# 802.3df D1.1

# Comment Resolution

P802.3df editorial team

Figure 173-3—32:8 PMA functional block diagram

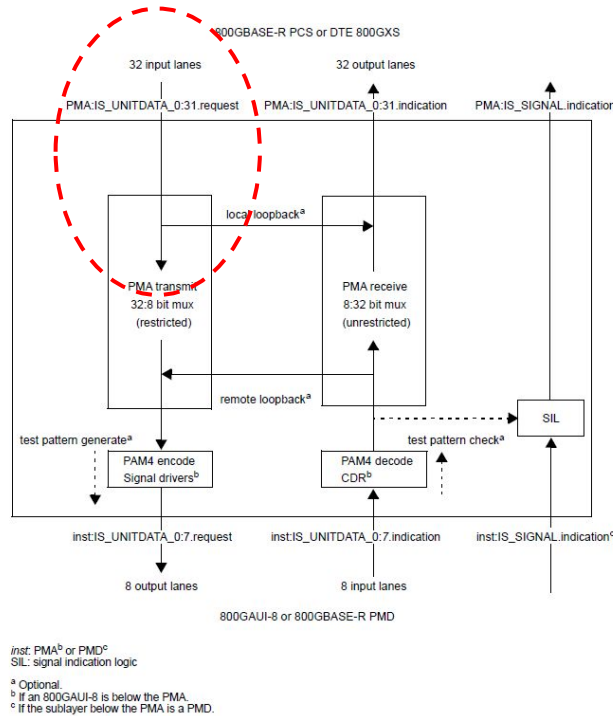
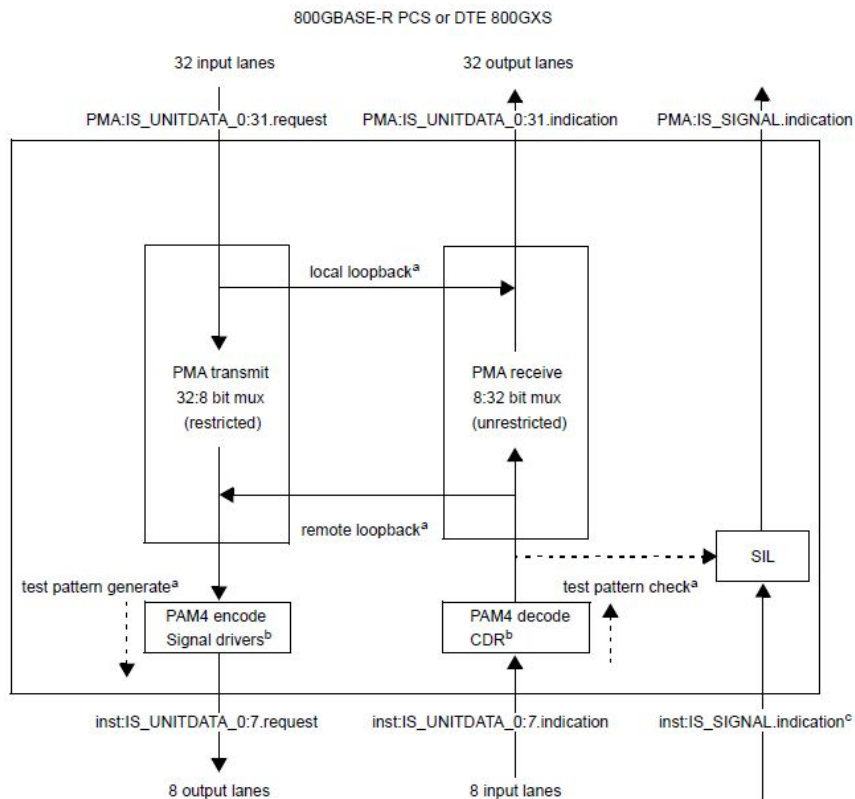
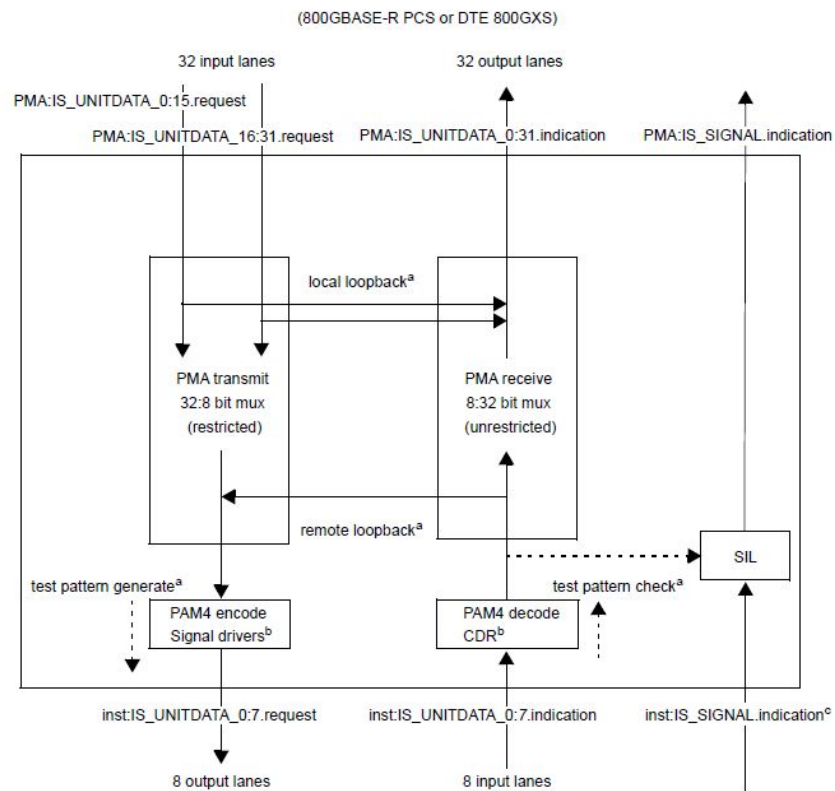
Cl 173 SC 173.4 P 217 L 6 # 87

Dawe, Piers Nvidia  
Comment Type T Comment Status D (bucket 1)

PMA:IS\_UNITDATA\_0:31.request would be better shown as PMA:IS\_UNITDATA\_0:15.request and PMA:IS\_UNITDATA\_16:31.request as in Figure 172-2. The PMA doesn't really know lane numbers, it doesn't read alignment markers, but it needs to know the two groups to apply the restricted bit muxing rules. The output lanes can stay as one group.

Show two groups of 16 input lanes, PMA:IS\_UNITDATA\_0:15.request and PMA:IS\_UNITDATA\_16:31.request. Similarly for the 32 PHY\_XS:IS\_UNITDATA\_0:31.indication lanes in Figure 173-4, 8:32 PMA functional block diagram.

**PROPOSED REJECT.**  
There are 32 PCS lanes represented by PMA:IS\_UNITDATA\_0:31. Figure 172-2 shows the two groups, one from 0:15 and the other from 16:31, to show how the lanes from each flow map to the set of 32 PCS lanes. Showing the separation of the two groups of lanes in this PMA diagram is not helpful. Since the PMA is connected directly to the PCS (colocated), the lane numbers are known by the PMA.

## 173.4.2.3 8:8 PMA bit-level multiplexing

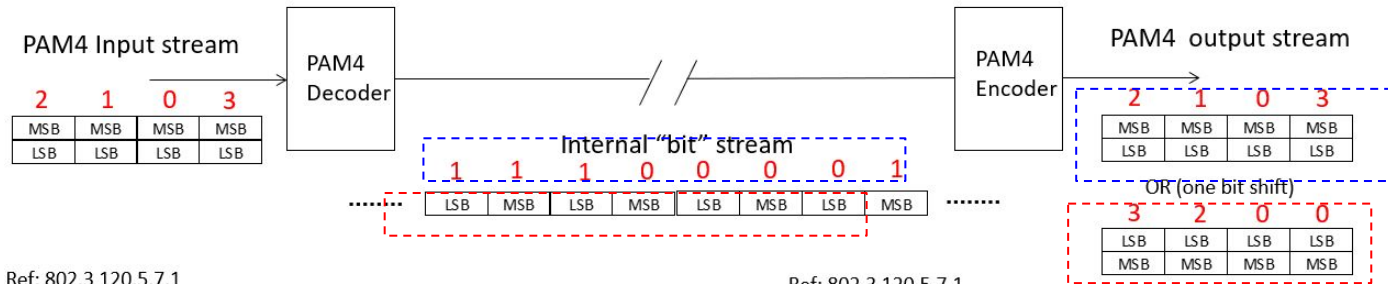
–The 4 PCSLs received on ~~any an~~ input lane shall be mapped to ~~the same an~~ output lane such that the Gray-coded PAM4 symbol sequence on the output lane is identical to the Gray-coded PAM4 symbol sequence on the input lane, except for possible swapping of each bit pair (see 173.4.7.1).  
~~The order of PCSLs from an input lane does not have to be maintained on the output lane.~~

### PAM4 Retimer (Adee's proposal)

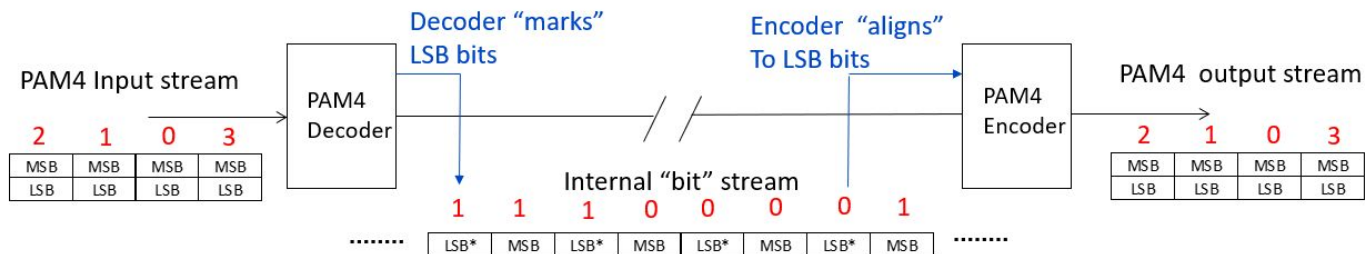
- In this case the PAM4 encoder is required to be "LSB/MSB locked (aligned)" to the PAM4 decoder
- Output PAM4 symbol stream is always the same as the input PAM4 symbol stream (assuming no errors)
- Note, how LSB/MSB aligned is achieved is an implementation choice (there are many possible options)
  - Including having a wide internal bus that is always LSB/MSB aligned (both at decoder and encoder)
